MEMORANDUM

Subject: Dunwoody Village Master Plan Update

Updated Street Improvements

8/11/2020 – As Revised following First Read

Chamblee Dunwoody Road Proposed Improvements

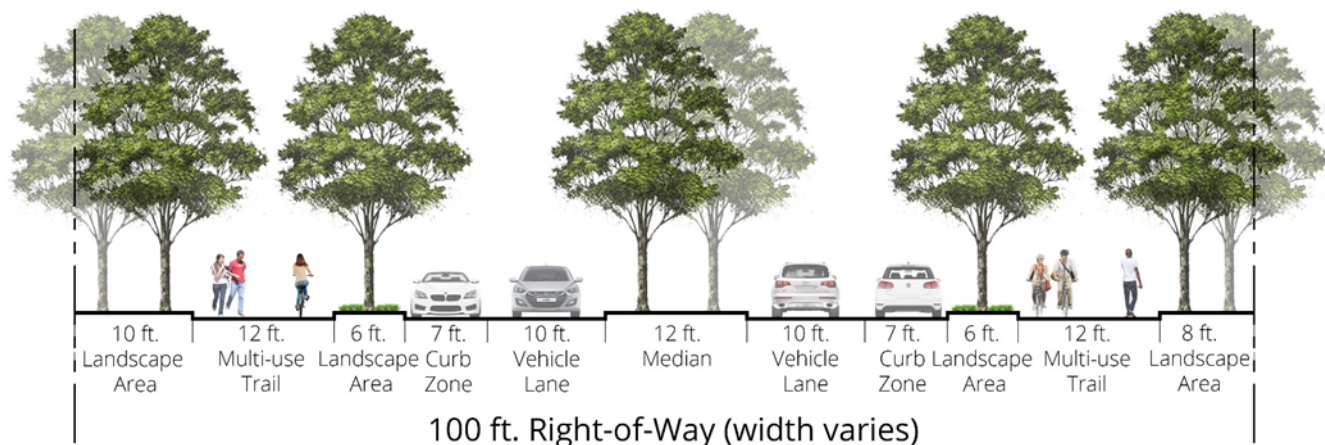
The following replaces the third column on page 43 and the first column on page 44:

Multi-modal improvements should be undertaken for Chamblee Dunwoody Road in one or more phases. The aspirational vision for Chamblee Dunwoody Road based on typical existing right-of-way is shown in the following section:

The above vision also assumes the following:

- A speed limit reduction to 25 miles per hour
- Street trees, pedestrian lighting, and roadway lighting
- Intersection enhancements including new mast arm traffic signals, pedestrian signals, high visibility crosswalks, and ADA Ramp improvements where necessary
- A design that minimizes the length of crosswalks to shortest distance necessary
- Removal of overhead utility lines and replace with underground utility lines
- Access management considerations to reduce and limit curb cuts and potential conflict areas along the corridor

Chamblee Dunwoody Road Proposed Improvements

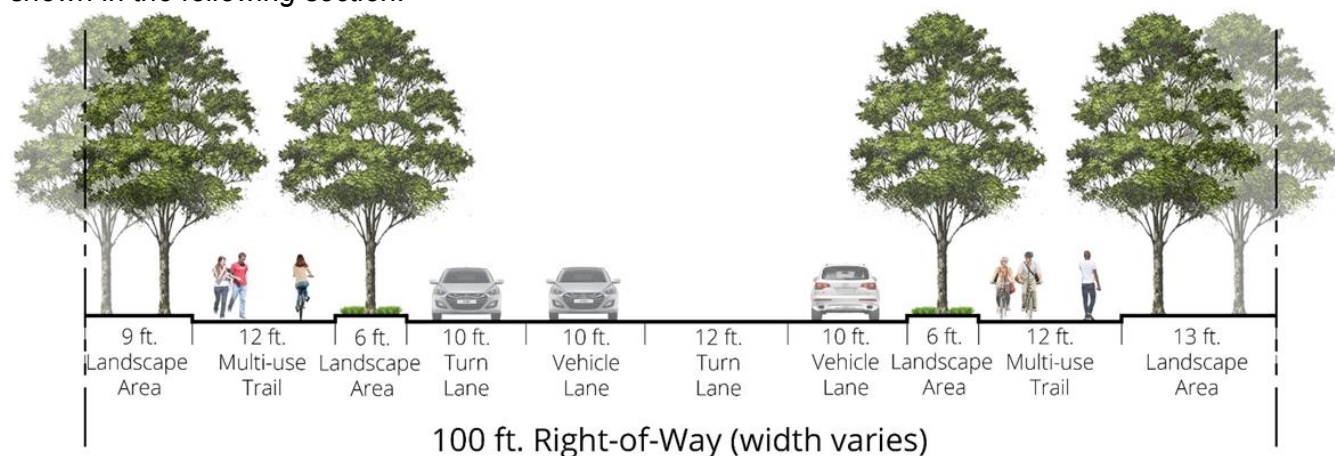
The following replaces the third column on page 43 and the first column on page 44:

Multi-modal improvements should be undertaken for Chamblee Dunwoody Road in one or more phases. The aspirational vision for Chamblee Dunwoody Road based on typical existing right-of-way is shown in the following section:

The above vision also assumes the following:

- A speed limit reduction to 25 miles per hour
- Street trees, pedestrian lighting, and roadway lighting
- Intersection enhancements including new mast arm traffic signals, pedestrian signals, high visibility crosswalks, and ADA Ramp improvements where necessary
- A design that minimizes the length of crosswalks to shortest distance necessary
- Removal of overhead utility lines and replace with underground utility lines
- Access management considerations to reduce and limit curb cuts and potential conflict areas along the corridor

Mount Vernon Road Proposed Improvements

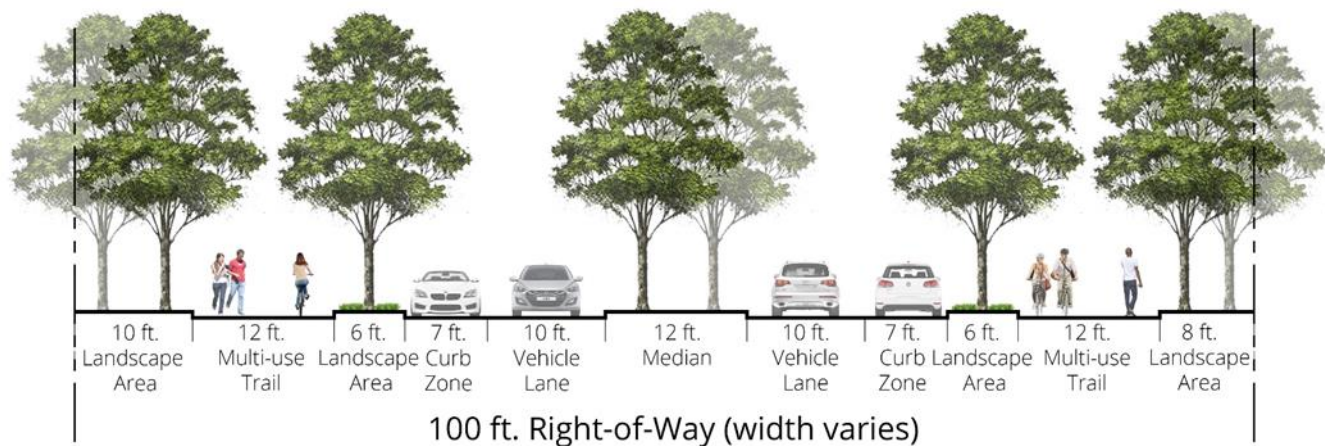
The following replaces the second column on page 44:

Multi-modal improvements should be undertaken for Mount Vernon Road. The aspirational vision for Mount Vernon Road based on typical existing right-of-way is shown in the following section:

The above vision also assumes the following:

- A speed limit reduction to 25 miles per hour
- Street trees, pedestrian lighting, and roadway lighting
- Intersection enhancements including new mast arm traffic signals, pedestrian signals, high visibility crosswalks, and ADA Ramp improvements where necessary
- A design that minimizes the length of crosswalks to shortest distance necessary
- Removal of overhead utility lines and replace with underground utility lines
- Access management considerations to reduce and limit curb cuts and potential conflict areas along the corridor

Chamblee Dunwoody Road Proposed Improvements

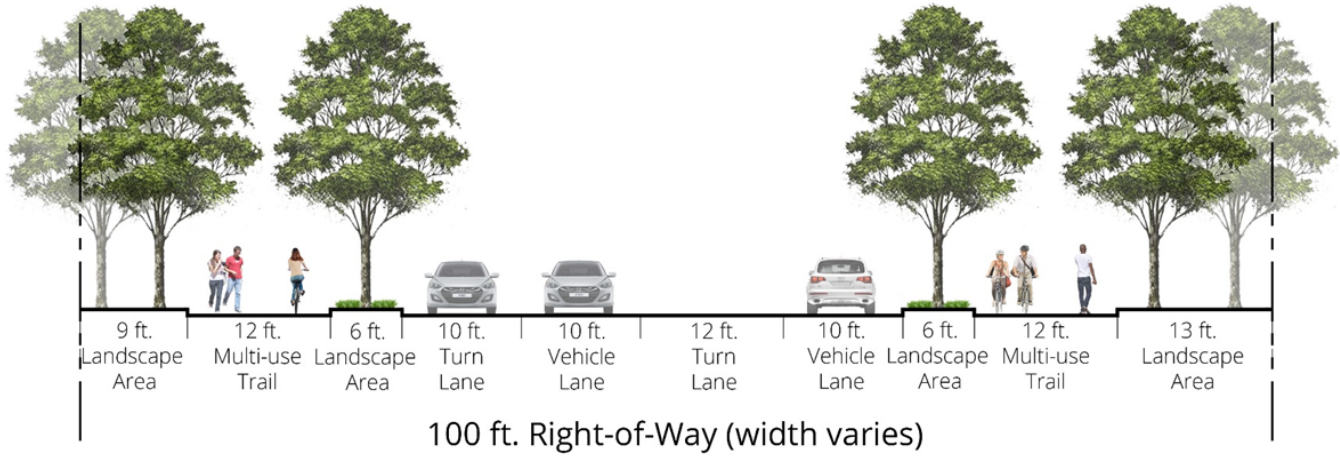
The following replaces the third column on page 43 and the first column on page 44:

Multi-modal improvements should be undertaken for Chamblee Dunwoody Road in one or more phases. The aspirational vision for Chamblee Dunwoody Road based on typical existing right-of-way is shown in the following section:

The above vision also assumes the following:

- A speed limit reduction to 25 miles per hour
- Street trees, pedestrian lighting, and roadway lighting
- Intersection enhancements including new mast arm traffic signals, pedestrian signals, high visibility crosswalks, and ADA Ramp improvements where necessary
- A design that minimizes the length of crosswalks to shortest distance necessary
- Removal of overhead utility lines and replace with underground utility lines
- Access management considerations to reduce and limit curb cuts and potential conflict areas along the corridor

Mount Vernon Road Proposed Improvements

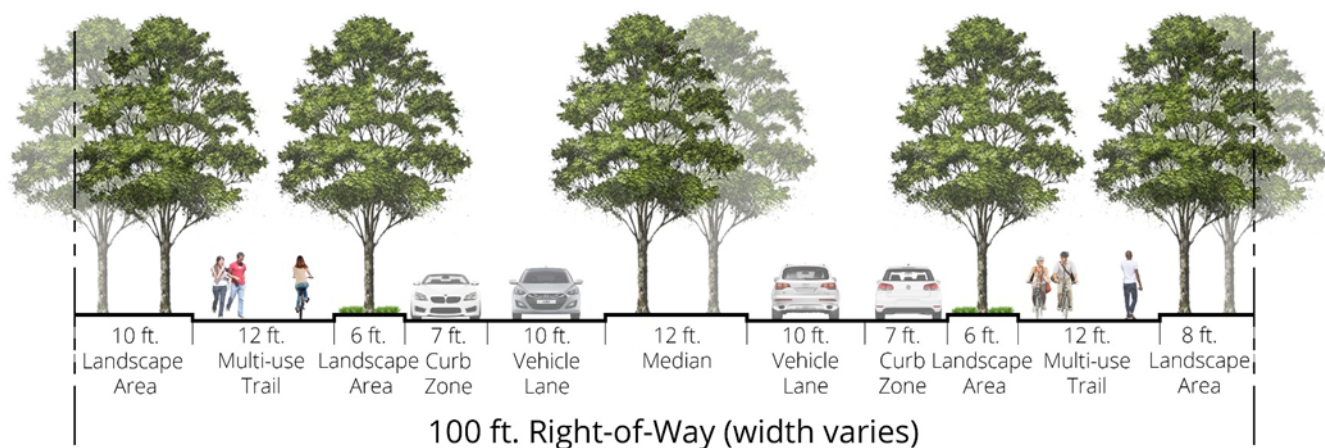
The following replaces the second column on page 44:

Multi-modal improvements should be undertaken for Mount Vernon Road. The aspirational vision for Mount Vernon Road based on typical existing right-of-way is shown in the following section:

The above vision also assumes the following:

- A speed limit reduction to 25 miles per hour
- Street trees, pedestrian lighting, and roadway lighting
- Intersection enhancements including new mast arm traffic signals, pedestrian signals, high visibility crosswalks, and ADA Ramp improvements where necessary
- A design that minimizes the length of crosswalks to shortest distance necessary
- Removal of overhead utility lines and replace with underground utility lines
- Access management considerations to reduce and limit curb cuts and potential conflict areas along the corridor
